Patent No.: 7,071,557 B2

For: METALLIZATION STRUCTURES
FOR SEMICONDUCTOR DEVICE
INTERCONNECTS, METHODS FOR
MAKING SAME, AND
SEMICONDUCTOR DEVICES
INCLUDING SAME

**REQUEST FOR CERTIFICATE OF CORRECTION OF PATENT
OFFICE MISTAKES (37 C.F.R. § 1.322)**

UNITED STATES PATENT AND TRADEMARK OFFICE CERTIFICATE OF CORRECTION

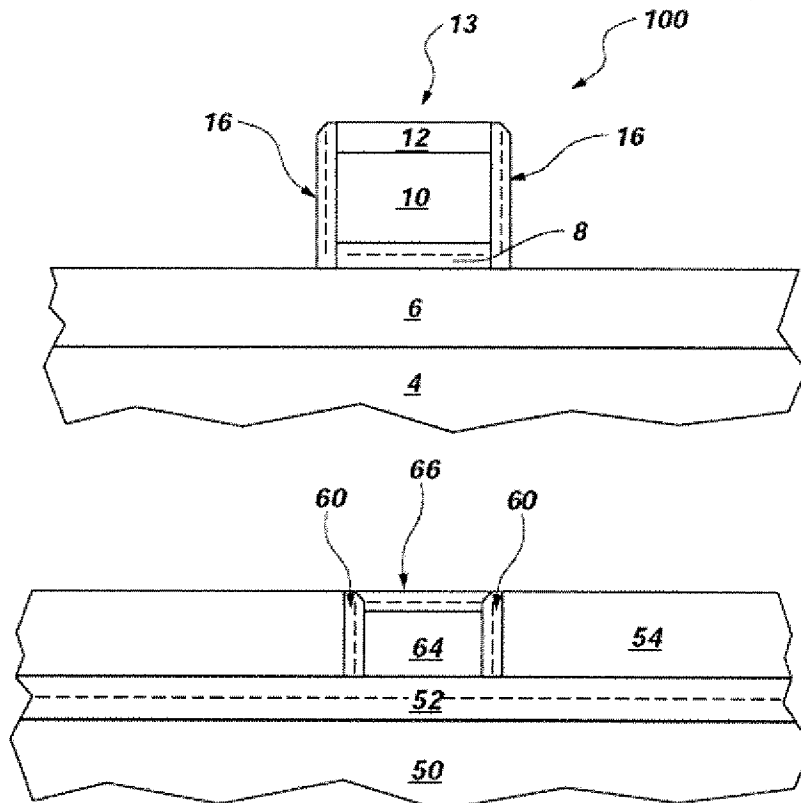
Replace the existing annotated figures at the bottom of the page with corrected formal drawings submitted June 26, 2001

Please replace the figures appearing on the title page with the following replacement figures:

Fig. 3a

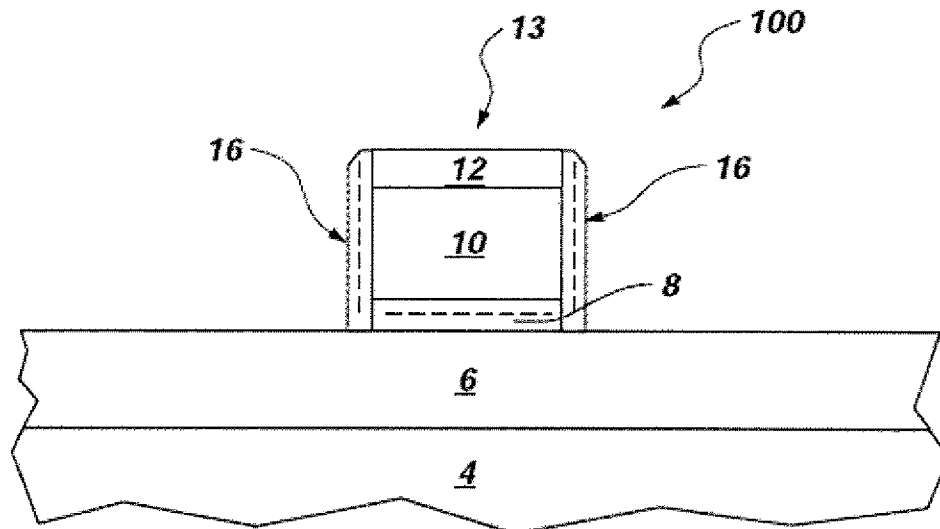
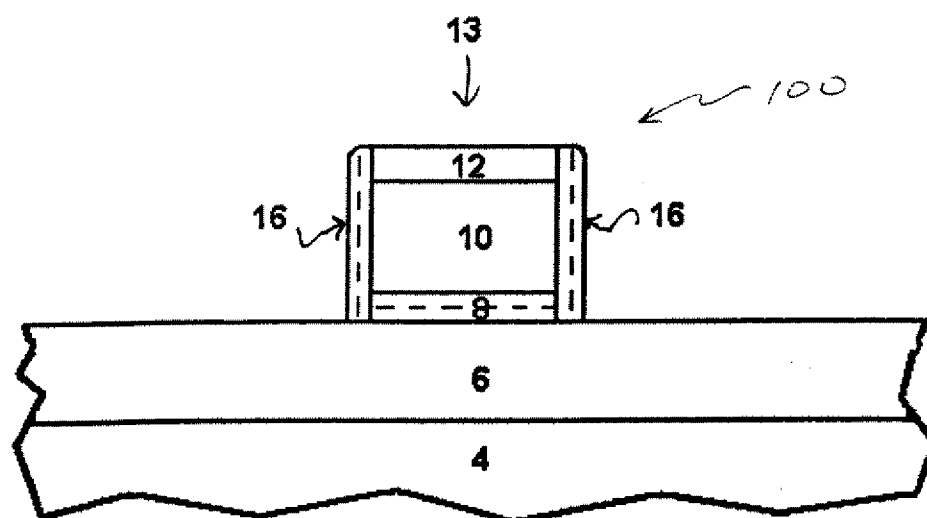
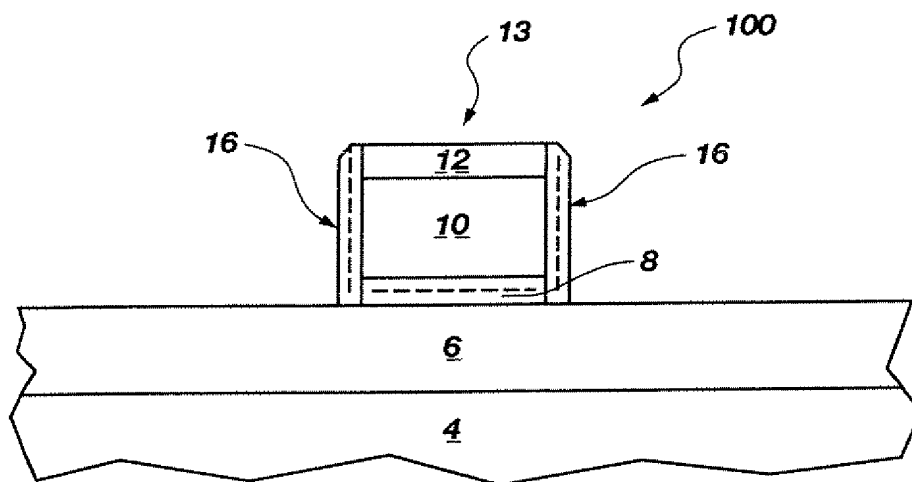
Figure 3a

Replace the existing annotated figure with the corrected formal drawing submitted June 26, 2001

Applicant submits herewith revised FIGS. 3a, 3b and 5 which correct errors in the drawings. Specifically, FIGS. 3a and 3b have been revised to add the reference numeral 100 with appropriate lead lines; and FIG. 5 has been revised to add the reference numeral 62a.

Please replace Fig. 3a with the following replacement figure:

Fig. 3b

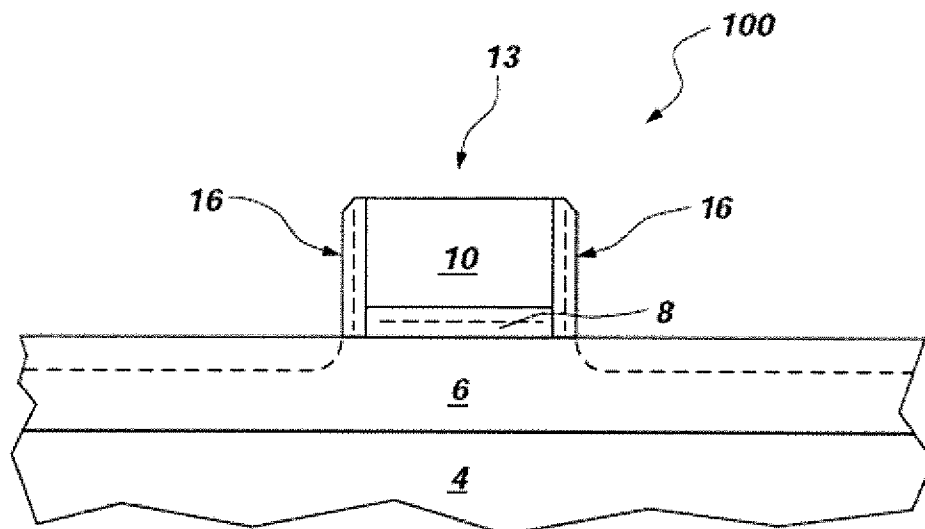
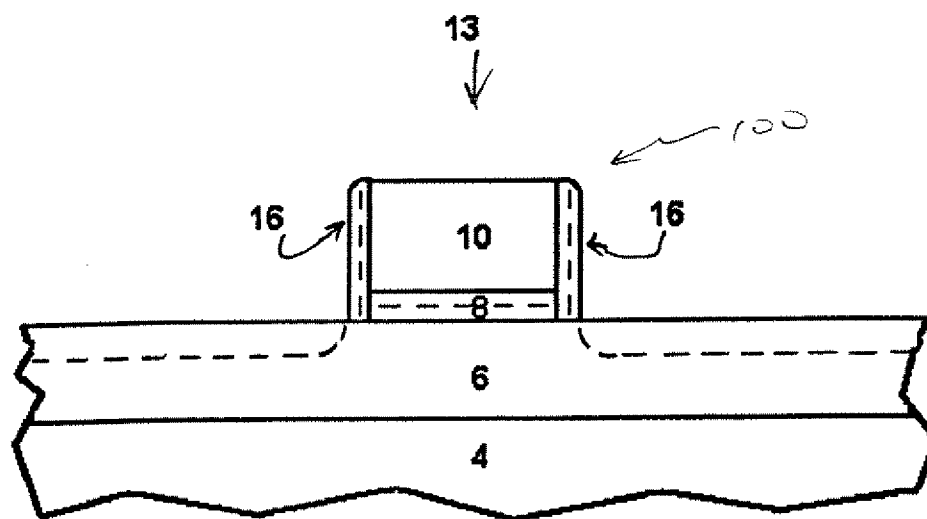
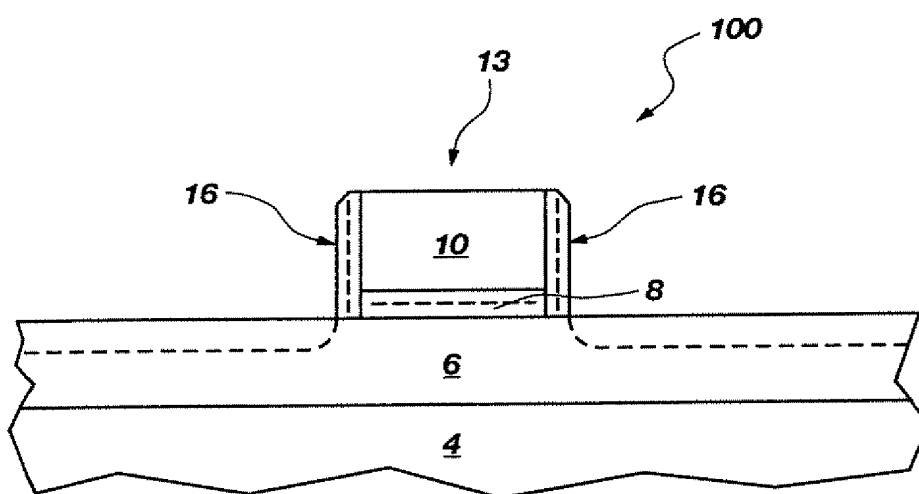
Figure 3b

Replace the existing annotated figure with the corrected formal drawing submitted June 26, 2001

Please replace Fig. 3b with the following replacement figure:

Fig. 5

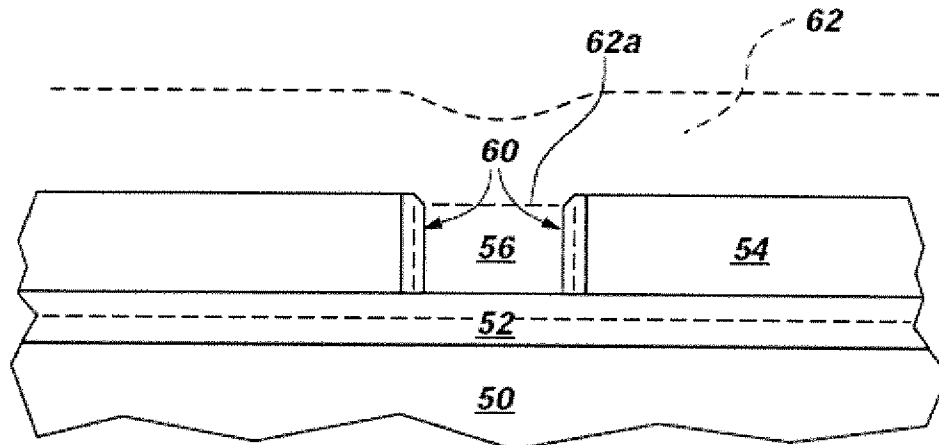
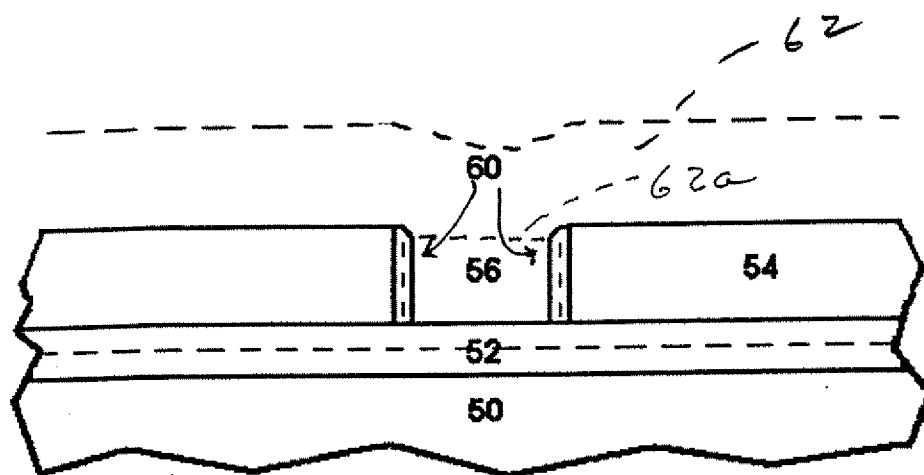
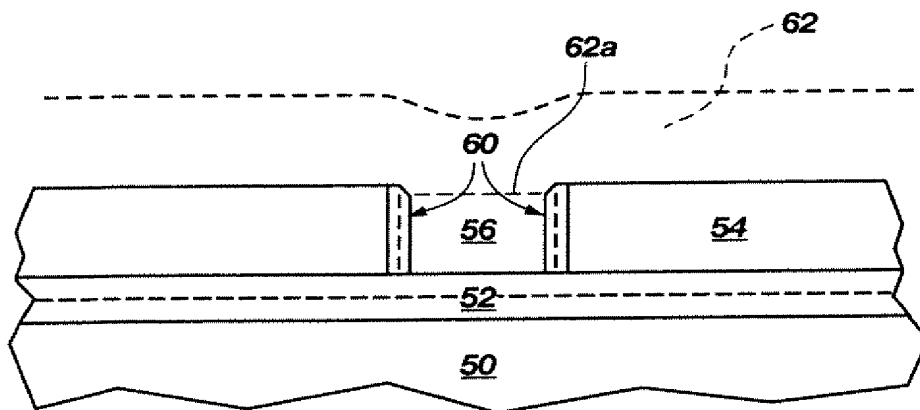
Figure 5

Replace the existing annotated figure with the corrected formal drawing submitted June 26, 2001

The drawings have now been objected to by the Examiner for failing to mention "element 62a." This drawing objection has been overcome by the enclosed copy of the above-identified Letter to the Chief Draftsman filed on August 4, 2000, a copy of the date-stamped postcard also being included herewith to evidence receipt of same by the Office. Applicant's undersigned attorney has recolored the proposed corrections on the copies of the revised drawings to assist the Examiner. Otherwise, the paper is as previously filed. Review and approval of the proposed revisions to the drawings is respectfully requested. Applicant will file a corrected set of formal drawings upon an indication that the proposed revisions are approved.

Please replace Fig. 5 with the following replacement figure:

Figure 3a

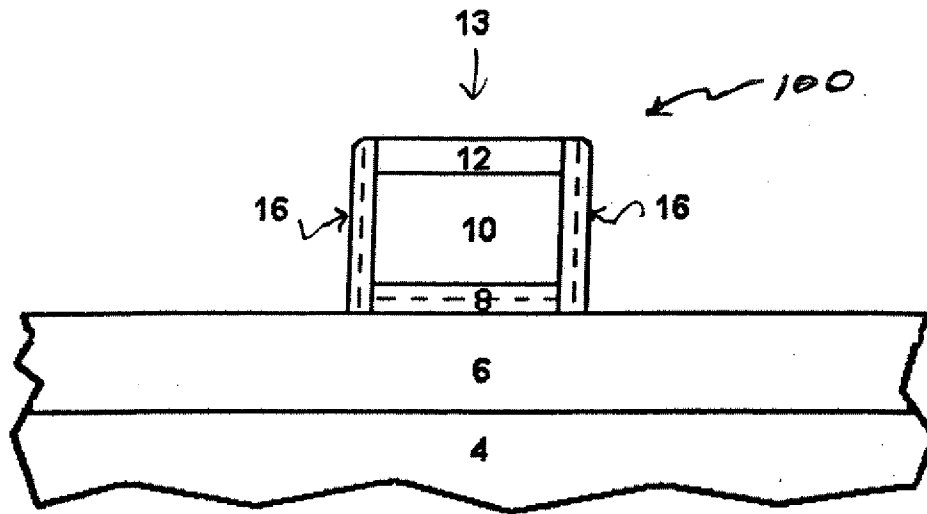
Applicant submits herewith revised FIGS. 3a, 3b and 5 which correct errors in the drawings. Specifically, FIGS. 3a and 3b have been revised to add the reference numeral 100 with appropriate lead lines; and FIG. 5 has been revised to add the reference numeral 62a.
